# UNITED STATES PATENT AND TRADEMARK OFFICE

| APPLICATION NO. | FILING DATE | FIRST NAMED INVENTOR | ATTORNEY DOCKET NO. | CONFIRMATION NO. |
|-----------------|-------------|----------------------|---------------------|------------------|
| 10/541,573      | 07/07/2005  | Shigeyuki Hatori     | TKI-006             | 7813             |

| <b>Office Action Summary</b> | <b>Application No.</b><br>10/541,573 | <b>Applicant(s)</b><br>HATORI, SHIGEYUKI |  |

**DETAILED ACTION**

**Note for reference character A-C, Y and Z, refer to the following:**

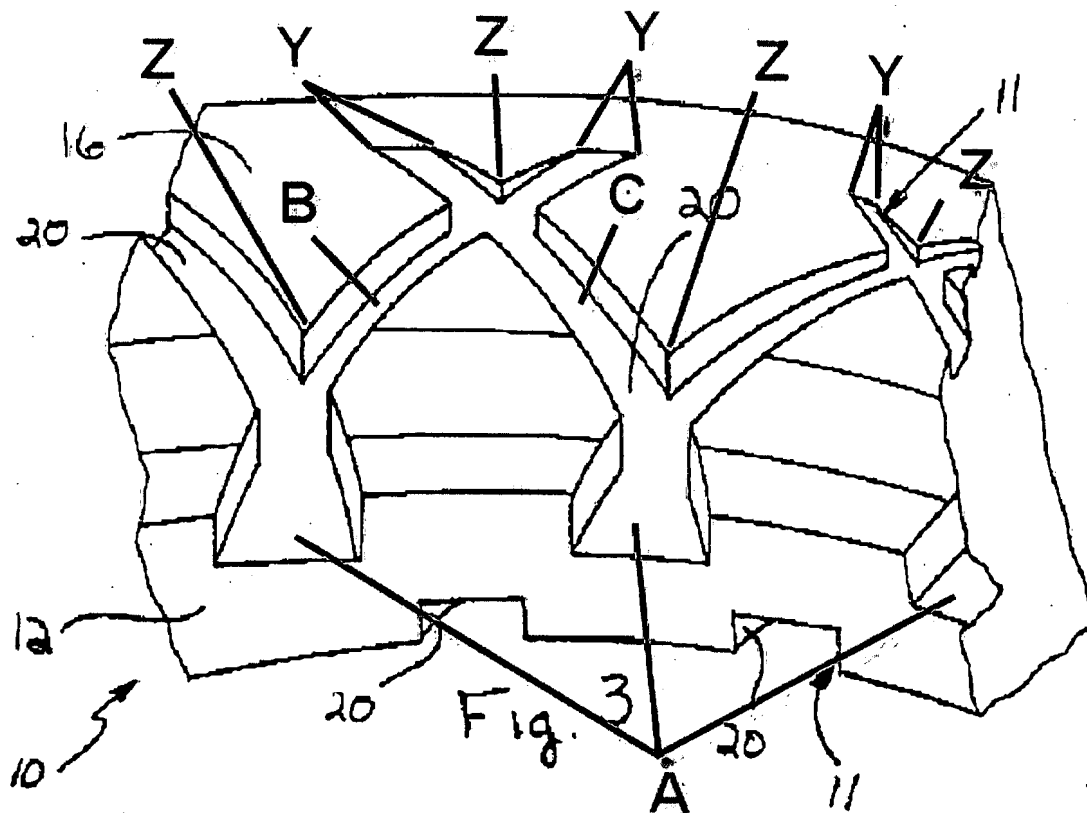
Regarding claim 1, the Dickey et al. reference discloses a seal ring (10) wherein a plurality of circumferentially extending concaves (20) being provided along an inner circumferential part of the contact side face (Fig. 3) and separated from each other along the circumference of the side face by columnar surfaces (e.g. Z),

each end of each of said plurality of circumferentially extending concaves converges with a surface of the side face to form a converging point (Y), adjacent converging points being separated from each other by said columnar surface (Fig. 3),

each of said columnar surfaces extending radially outwardly from a line extending between adjacent converging points to an outer circumferential edge of the side face (Fig. 3),

each of the concaves being formed by a first deepest inclined portion (e.g. portion at A) provided in the inner circumferential part of the side face of the seal ring, the first deepest inclined portion being provided to reduce a thickness of the seal ring toward an inner circumference of the seal ring (Fig. 3), and

a second inclined portion (e.g. B and C) being provided on an inner circumferential side of each columnar surface and extending radially inwardly from said line extending between adjacent converging points to the inner circumferential edge of the side face of the seal ring to reduce the thickness of the seal ring toward the inner circumference of the seal ring (Fig. 2).
